Access Compliance Report

Public Rights-of-Way

Intersection ID: 3544	Main Street: VOLUSIA_CT	Cross Street: WEAVERS_GLENN_PL	Location: W
ADA ID: 91DB2B79E2F9	Ramp Type: PerpDiag	Initial Pass/Fail: Fail	Overall Compliance: No
Severity Score: 33.75			
Codes/Mitigation Info/Possible Solution		Field Measurements/Component Compliance

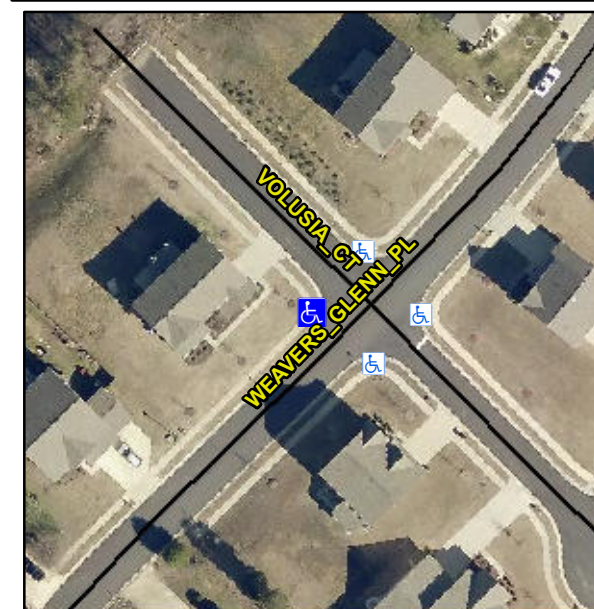
Not Found, R304.5.1, R304.5.3

Compliance	Description	Data	Compliance	Description	Data
N/A	Ramp Length (in)	48.0	Yes	Ramp Slope (%)	7.8
No	Ramp Width (in)	47.0	No	Ramp XSlope (%)	9.1
N/A	Flare Type LT	N/A	N/A	Flare Type RT	N/A
N/A	Flare Slope LT (%)	N/A	N/A	Flare Slope RT (%)	N/A
N/A	Flare Traversable LT?	N/A	N/A	Flare Traversable RT?	N/A
N/A	Landing Length (in)	N/A	N/A	DWS Provided?	N/A
N/A	Landing Width (in)	N/A	N/A	DWS Contrast?	N/A
N/A	Landing Slope (%)	N/A	N/A	DWS Length (in)	N/A
N/A	Landing X Slope (%)	N/A	N/A	DWS Full Width?	N/A
N/A	Landing Curb? (Y/N)	N/A	N/A	DWS Offset (in)	N/A
N/A	Shared Landing?	N/A			
N/A	Gutter Ponding?	N/A	N/A	Gutter Slope (%)	N/A
N/A	Gutter Lip Ht (in)	N/A	N/A	Gutter X Slope (%)	N/A
N/A	Painted X Walk1?	No	N/A	Painted X Walk2?	No
	X Walk 1 Direction	To SE		X Walk 2 Direction	To NE
N/A	X Walk 1 Width (in)	N/A	N/A	X Walk 2 Width (in)	N/A
	X Walk 1 Slope (%)	1.5		X Walk 2 Slope (%)	11.5
	X Walk 1 X Slope (%)	12.4		X Walk 2 X Slope (%)	2.9

Remove & Replace Curb Ramp With Two New Directional Ramps or Equivalent.
